Rear Axle Filtration Kit

For 785C and 789C Off-Highway Trucks

Cat® 785C and 789C Rear Axle Filtration Kit

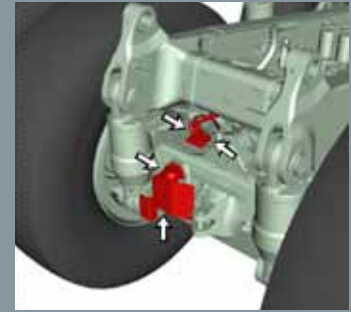
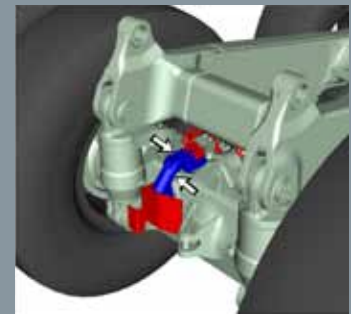
This filter retrofit replaces the existing oil filter and relocates it to the top of the housing. Both kits contain the (334-0572) filter group which includes a 328-3655 advanced efficiency filter element for improved oil cleanliness. The new filter element has an 11 micron maximum rating, compared to a 20 micron maximum rating of the previous filter element. The new element also has a larger media surface area which increases dirt holding capacity from 70 gms to 210 gms.

The new filtration system provides a cleaner system with a more conveniently located filter group.
